**SUBJECT: REQUEST FOR ADDITIONAL INFORMATION REGARDING
COMMUNITY PLAN AMENDMENT AND CHANGE IN ZONING
FOR KAHANA SUNSET AOA (LAHAINA) (LU-19)**

**KAHANA SUNSET AOA APPLICATION FOR A CHANGE IN
ZONING (CIZ) AND COMMUNITY PLAN AMENDMENT (CPA),
SITUATED AT 4909 LOWER HONOAPIILANI ROAD, LAHAINA,
ISLAND OF MAUI, HAWAII; TMK: (2) 4-3-003:015 (CPA 2012/0003)
(CIZ 2012/0007)**

**MAUI COUNTY PLANNING DEPARTMENT'S REPORT
TO THE MAUI PLANNING COMMISSION
JULY 22, 2014 MEETING**

**Community Plan Amendment, Change in Zoning, Special Management Area Use Permit and
Shoreline Setback Variance**

Figure 3. Project Area Master Plan

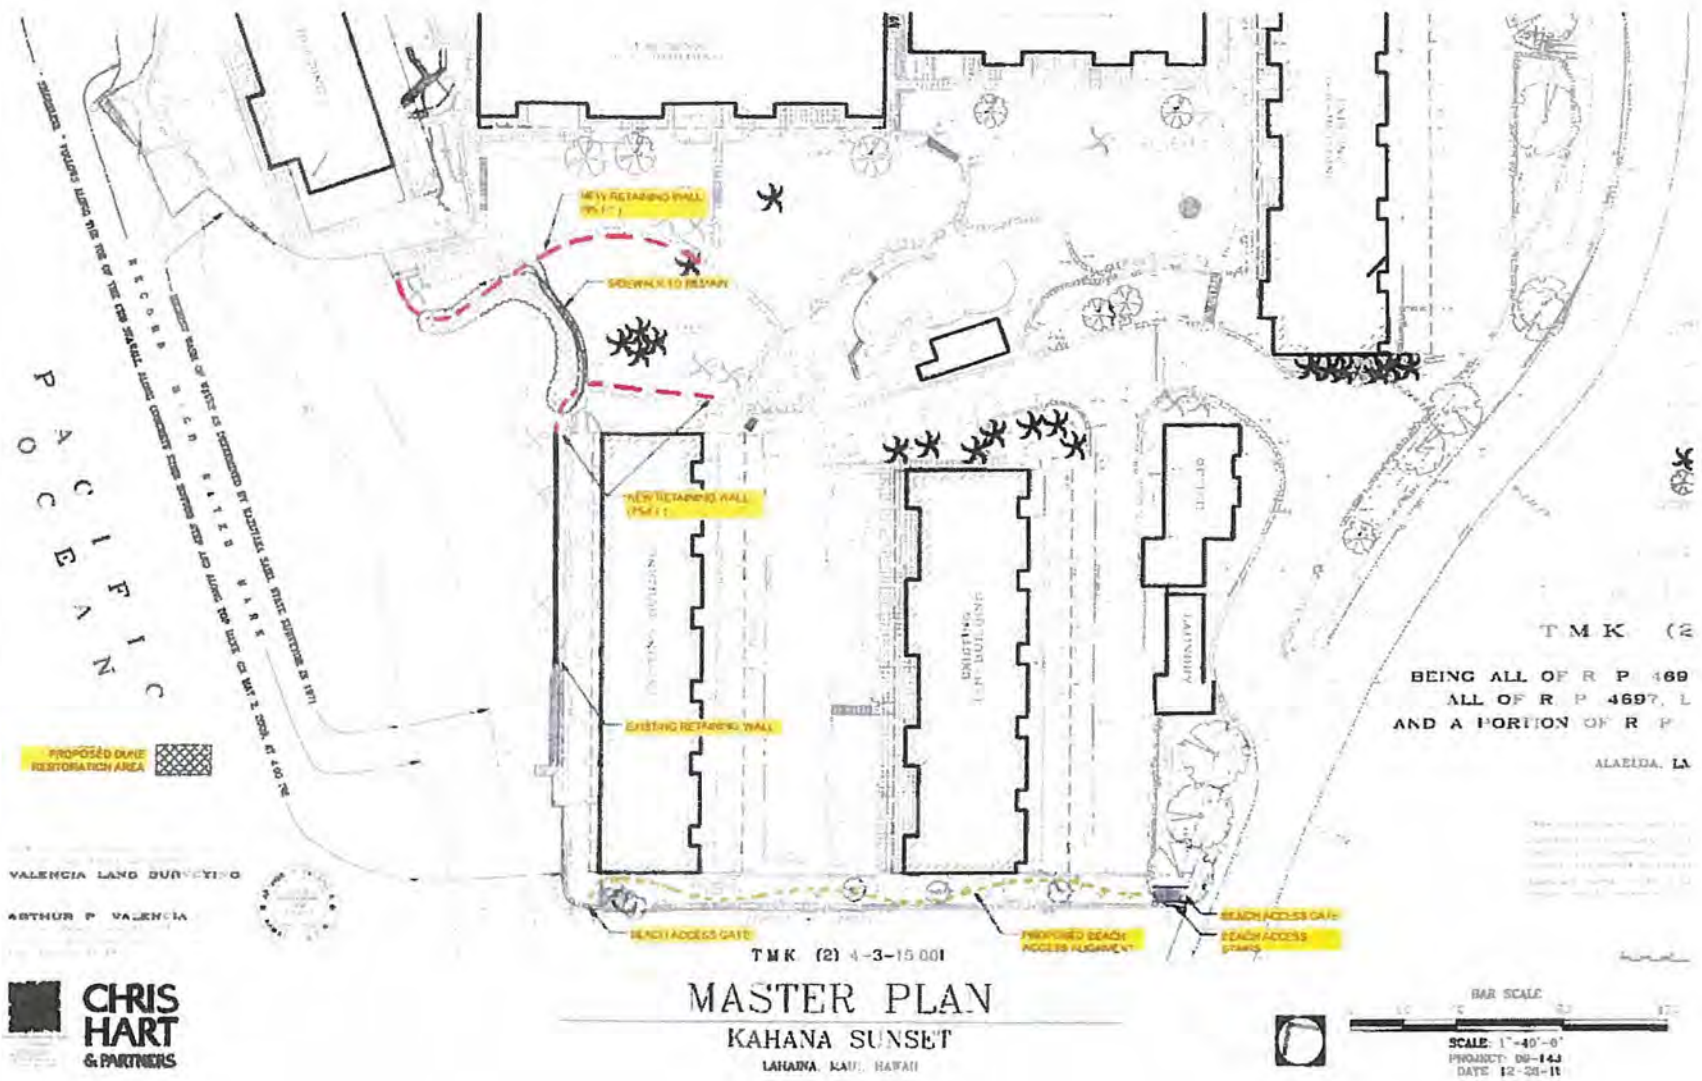
3. The Department asks that the Applicant include an analysis of the proposed new seawall's impacts on the beach profile fronting the seawall location, as depicted in Figure 10 of the Concept Master Plan. In Figure 10, the location of the new seawall at the drain outfall and north of the proposed stairs forms a convex plan-view shape, creating a lawn behind the seawall between the proposed new walkways and the drainage outlet area. The Applicant is asked to analyze the impact that this convex configuration of the seawall will have on focusing wave energy against the seawall, resulting in potential future loss of beach at this location. The Department reasons that if beach is lost due to the seawall plan-view convex configuration, as proposed, then the Applicant will be faced with a similar situation of an undermined seawall at this location. However, if the proposed seawall is reconfigured in a concaved plan-view shape, eliminating the lawn area between the drain outfall and the new stairs and replacing the lawn with more sandy beach, the Department reasons that a concaved-plan-view configuration will further dissipate wave energy at this location, which in turn will build a sandy beach, preserving a beach and further protecting the seawall from direct wave energy. The proposed convex

plan-view seawall configuration in Figure 10 will focus wave energy on the seawall, which, in turn, will remove sand at the beach in front of the proposed seawall, leading to potential further erosion and requirement for further seawall protection. Please examine this suggested change in seawall configuration to a concaved seawall plan-view configuration in Figure 10 as part of the Final EA.
